Title: APPARATUS AND METHOD FOR CUTTING ELECTRODE FOIL

LAYERS

## PRE-APPEAL BRIEF REQUEST FOR REVIEW

Applicant traverses with the objection to the drawings and the rejection under 35 U.S.C. 112, second paragraph. Figures 7A and 7B of the application are reproduced below for reference.

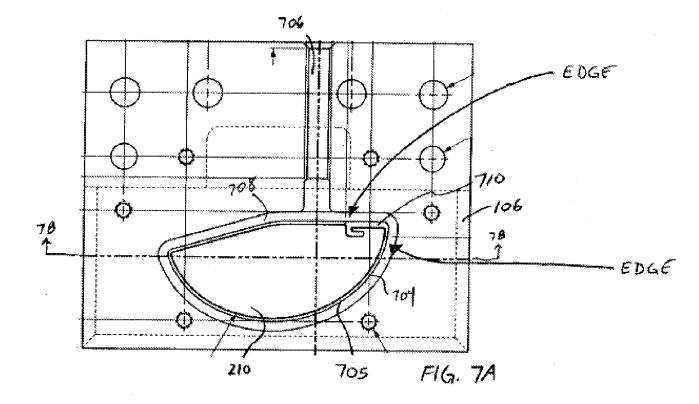
The Examiner stated that "the limitation of "the ridge including an opening to the interior of the die hole" in claims 10 and 65 must be shown or the feature(s) canceled from the claim(s)." (Page 2 of Final Office Action). The Examiner further stated "that element 705 represented a ridge does not have any discontinuous section to be called "an opening.""

In the Advisory Action, the Examiner states that "In the pre-selected area 710, the ridge 705 still exists but does not discontinue as asserted by the applicant and is best seen in the right side of Fig. 7B. If there is a discontinuity on the ridge 705, the lubricant flows into the die hole which is not desirable for a punching process."

As can be seen in Figures 7A and 7B, die hole 210 is surrounded by a lubrication dam 704, which is defined by a ridge 705. A feed conduit 706 feeds lubricant to a lubrication reservoir area 708. A pre-selected area 710 is open (i.e. ridge 705 does not extend through area

710) such that lubrication delivered via conduit 706 is directed towards hole 210 only through opening 710, while the ridge 705 holds the lubrication back around the rest of the periphery.

For reference, in Figure 7A Applicant has pointed out the end edges of the ridge 705 that define opening 710, which is located between the end edges of the ridge 705. In Figure 7B, the opening 710 is located at the upper surface of the hook-shaped die portion where the lubricant is to be delivered. Although this hook-shaped die portion may be slightly higher than the floor of area 708 it is lower than the ridge 705 extending around the rest of the periphery of the die hole. Since location 710 is lower than the ridge 705, lubricant is allowed to flow towards the die hole 210 and onto the surface of the hook-shaped portion, as explained in the specification and shown in the Figures.

Accordingly, the subject matter of "the ridge including an opening to the interior of the die hole" in claims 10 and 65 is present in the specification and shown in the figures; and element 705 representing a ridge does have an opening 710, which is open to die hole 210.

Applicant traverses these statements. Again, Figure 7B shows that the location 710 is slightly higher than the floor of area 708 and is lower than the ridge 705 extending around the rest of the periphery of the die hole. Ridge 705 does not extend through opening 710. Instead, lubricant is allowed to flow through that area to the die hole.

Moreover, in contrast to the Examiner's assertion that "[i]f there is a discontinuity on the ridge 705, the lubricant flows into the die hole which is not desirable for a punching process," Applicant submits that the purpose of the discontinuity 710 is to allow the lubricant to flow towards the die hole at that point. As discussed in the application: "A pre-selected area 710 is open (i.e. ridge 705 does not extend through area 710) such that lubrication delivered via conduit 706 is directed towards hole 210 only through opening 710, while dam 704 holds the lubrication back around the rest of the periphery." (Page 7, lines 15-18). Figs. 7A and 7B clearly show the discontinuity of the ridge 705 at the edge points described above, thereby defining location 710.
